ECE/TRANS/WP.29/GRPE/2007/12  
26 March 2007

**REGULATION No. 110**

Proposal for draft amendments to Regulation No. 110  
(Specific components for CNG)

Submitted by the expert from the International Organization of Motor Vehicle Manufacturers

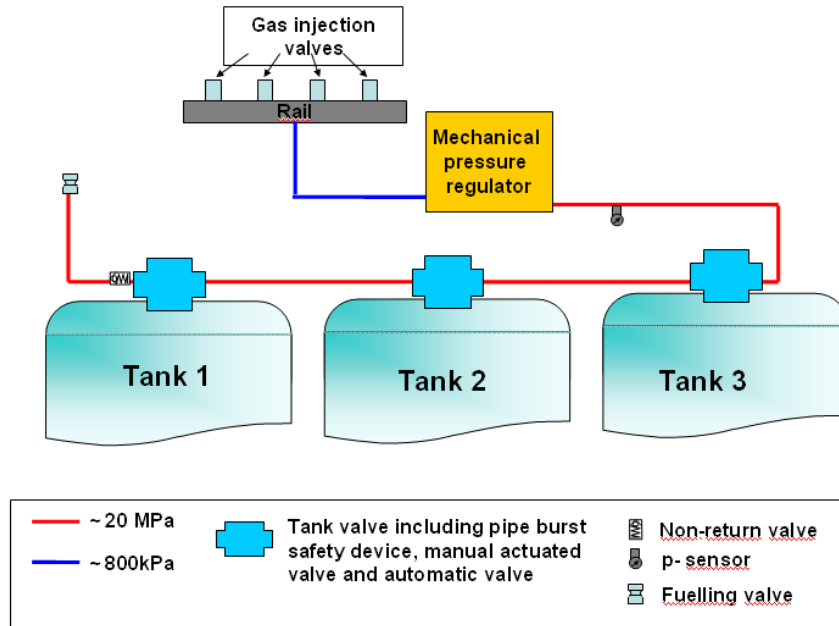
17.5.1.1. An automatic cylinder valve shall be installed directly on each container. **However, if the cylinder is equipped with automatic admission-pressure control or OBD-monitoring, the automatic valve may be positioned separately from the container.**

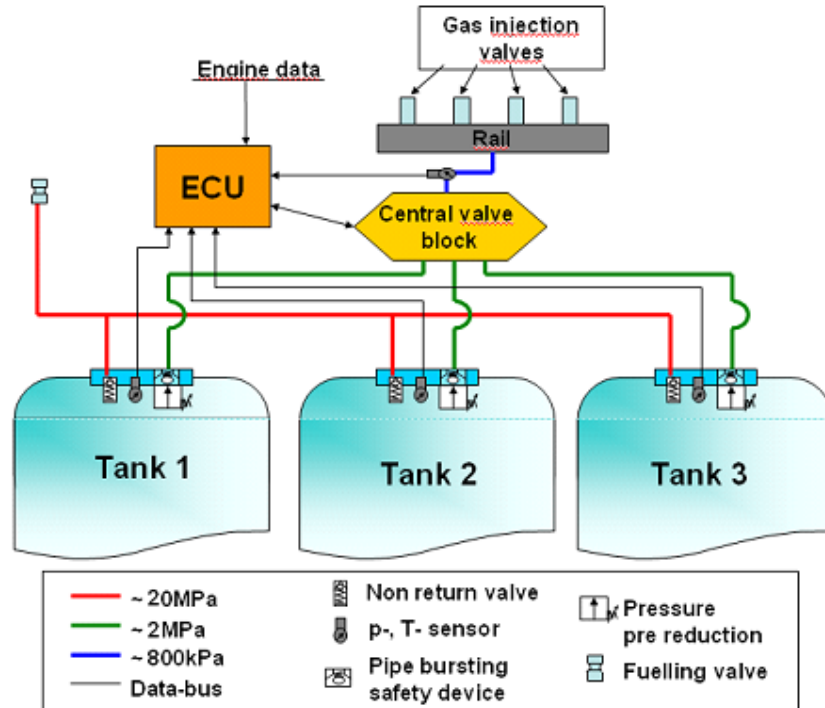
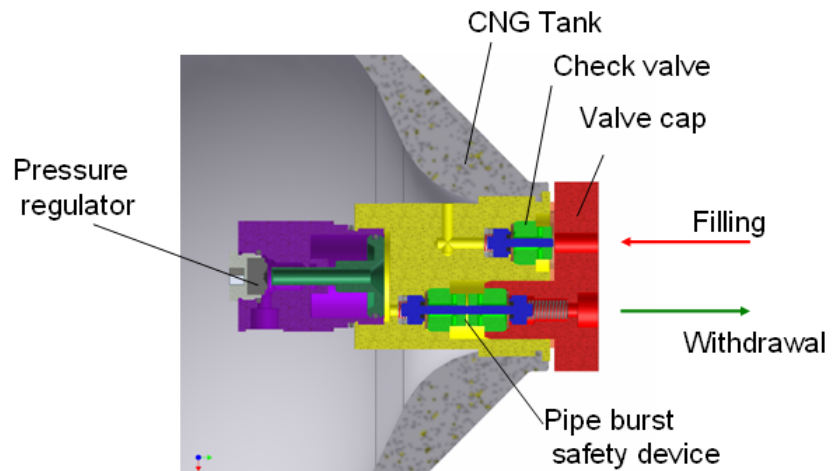
Current System Concept

Current systems are heavy and expensive and are not diagnosable.

New System Concept

The new system will have three pressure areas with a very simple mechanical pressure regulator integrated in the tank valve, and an electronic pressure regulator near the engine:

- (a) High pressure area: 20 MPa
- (b) Medium pressure area: about 2 MPa
- (c) Low pressure area: about 800 kPa (depending on engine demand)
